NOTICE OF SWIMMING POOL NON-COMPLIANCE

Premises to which this notice relates: 102 Bantry Bay Road Frenchs Forest.

Pool Installation Description: In-ground concrete swimming pool

Above is a diagram showing internal barriers less than 1800mm high non climb zones.

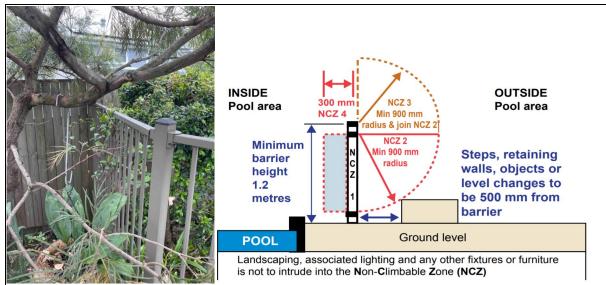
A Shrub was within the 900 mm Non-Climb Zone (NCZ 2 & 3) on the outside of the pool fence. The 900 mm NCZ is required to be kept clear so that children cannot use any object close to the fence to assist them to climb into the pool enclosure.

Prune or remove the Shrub so that no climbable branches are within the 900 mm NCZ. The NCZ is a 900 mm arc measured from the top of the fence and extends upward above the fence (ie the 900 mm NCZ is semi-circular in shape).

Alternatively, if the section of barrier opposite the climbable vegetation is replaced or extended so the barrier is 1800mm or more in height the climbable vegetation could remain as it is. AS 1926.1 - 2012 (the Australian Standard used to assess your barrier) has a section (2.2.3) that allows internal barriers greater than 1800mm high to NOT require any Non Climb Zones (NCZ's).

Boundary barrier non climb zone requirement Below are some examples of newly installed 1800mm high internal barrier for vegetation

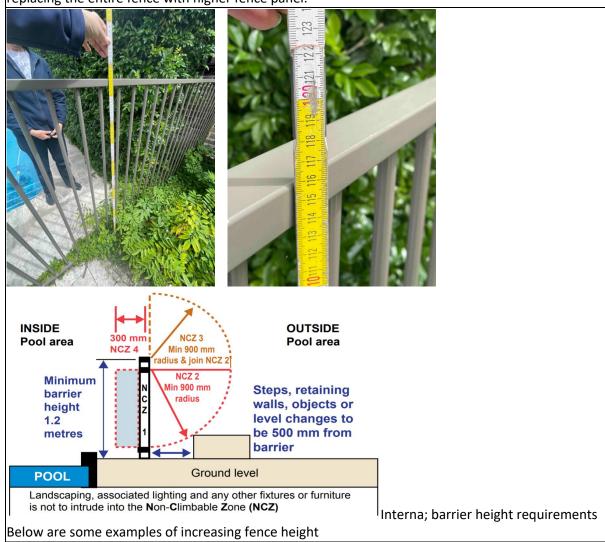
A hedge was located on the inside of the boundary fence that could be used as a foothold for children to climb down into the pool enclosure.

Remove or prune the hedge so that no branch is within the 900 mm NCZ 5.

Alternatively, if a new 1800mm high internal barrier is installed between the vegetation and the swimming pool the climbable vegetation could remain as it is. AS 1926.1 – 2012 (the Australian Standard used to assess your barrier) has a section (2.2.3) that allows internal barriers greater than 1800mm high to NOT require any Non Climb Zones (NCZ's). See example photographs below.
